> Calvert Cliffs Nuclear Power Plant, Unit Nos. 1 and 2 Renewed Facility Operating License Nos. DPR-53 and DPR-69 NRC Docket Nos. 50-317 and 50-318

Request for Additional Information Regarding the National Fire Protection Association Standard 805 License Amendment Request

Calvert Cliffs Nuclear Power Plant February 9, 2015

REQUEST FOR ADDITIONAL INFORMATION REGARDING THE NATIONAL FIRE PROTECTION ASSOCIATION STANDARD 805

Figure 15: Impact of Sensitivity in Terms of Change to Unit 1 CDF

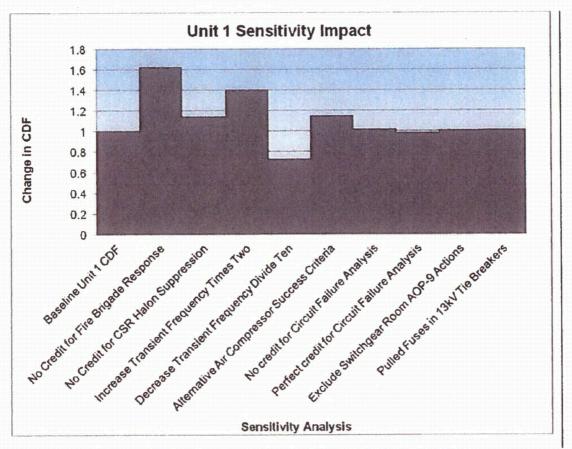
CCNPP RESPONSE PRA RAI 16:

The risk information presented in Attachment W is based on point estimate calculations. This is considered a reasonable approximation to the equivalent mean calculation. The state-of-knowledge correlation (SOKC) only causes the mean to be larger when multiple correlated parameters appear in a single cutset. The vast majority of the cutsets contain only uncorrelated parameters (e.g. fire scenario frequency, a single HRA failure likelihood, and a non-suppression probability). There are cutsets that contain multiple operator actions, but these events are already evaluated as a joint failure probability which addresses the correlation issue. There are also cutsets which could contain multiple circuit failure likelihood values. The CCNPP FPRA uncertainty notebook (C0-UNC-001 Revision 1) indicates only a minor change in the risk when circuit failure likelihoods are not credited (see sensitivity analysis summary below, for Unit 1 (Unit 2 similar):

Given the above, the use of point estimates in the delta risk calculations is considered to be appropriate.
